DUKE POWER COMPANY  
OCONEE NUCLEAR STATION

ATTACHMENT 1  
TECHNICAL SPECIFICATIONS

This section provides the technical justification for the proposed modifications to the ONS Technical Specifications. These changes revise certain Design Features specifications to address two new fuel designs, increase the initial fuel enrichment, and establish restricted loading patterns and associated burnup criteria for qualifying fuel in both Spent Fuel Pools at the Oconee Nuclear Station. These changes are necessary to allow storage and irradiation of fuel for the upcoming Unit 3 Cycle 16 reload core. These changes will also increase design and operational flexibility, while at the same time maintaining acceptable criticality safety margins and decay heat removal capabilities. In addition, several administrative changes have been included in order to provide clarity to the Specifications and bring them more in line with the NUREG-1430 B&W Standard Technical Specification (STS) format. A description of each of the changes being requested is given below.

**Figure 3.8-2**  
Required Loading Pattern for Restricted Storage  
in the Unit 3 Spent Fuel Pool

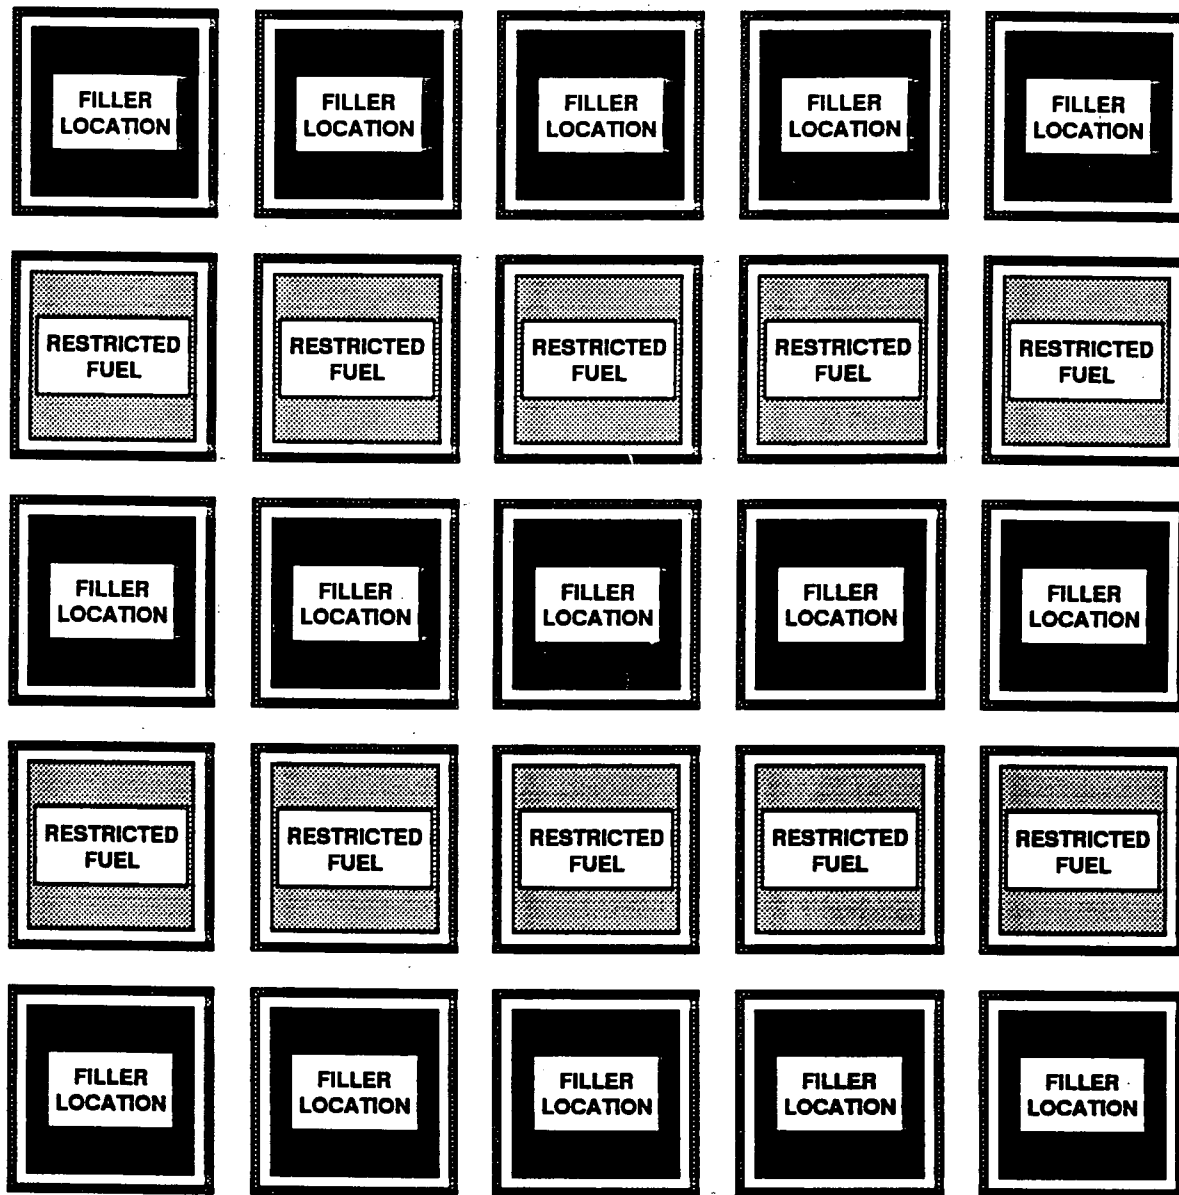
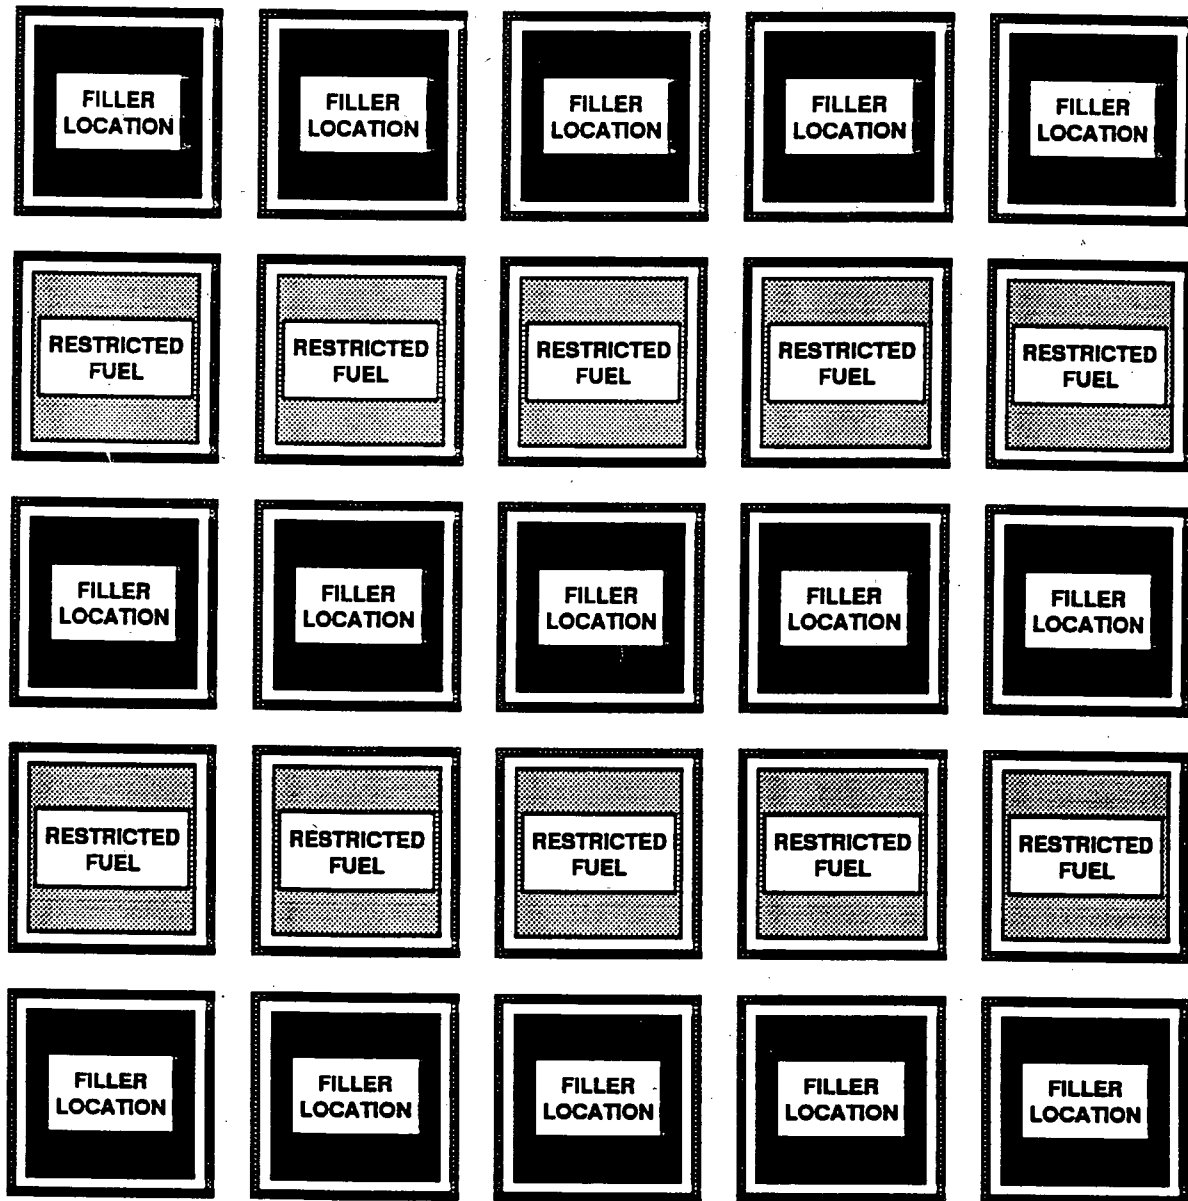
- 1). Unrestricted storage of fuel meeting the criteria of Table 3.8-3; or
- 2). Restricted storage in accordance with Figure 3.8-2, of fuel which does not meet the criteria of Table 3.8-3; or
- 3). Another configuration determined to be acceptable by means of an analysis to assure that  $k_{eff}$  is less than or equal to 0.95.

2. The Technical Specification List of Tables and List of Figures is being changed to add Tables 3.8-1 through 3.8-4, and Figures 3.8-1 and 3.8-2 which are both part of the new Specification 3.8.16 (see number 4 below). This change is purely administrative.

4. Specification 3.8.15 (fuel enrichment) is being replaced with Specifications 3.8.15 (Spent Fuel Pool boron concentration), 3.8.16 (fuel storage), and 3.8.17 (action statements). These changes are being made in order to accommodate the added Spent Fuel Pool (SFP) storage restrictions and to provide increased operational flexibility. This change also provides more consistency with STS format.

**Restricted Fuel:** Fuel which does not meet the minimum burnup requirements of Table 3.8-3. (Fuel which does meet the requirements of Table 3.8-3 may be placed in restricted fuel locations as needed)

**Filler Location:** Either fuel which meets the minimum burnup requirements of Table 3.8-4, or an empty cell.

**Boundary Condition:** Any row bounded by an Unrestricted Storage Area shall contain a row of filler locations (i.e. A row of Restricted fuel assemblies may not be adjacent to a row of Unrestricted fuel assemblies).
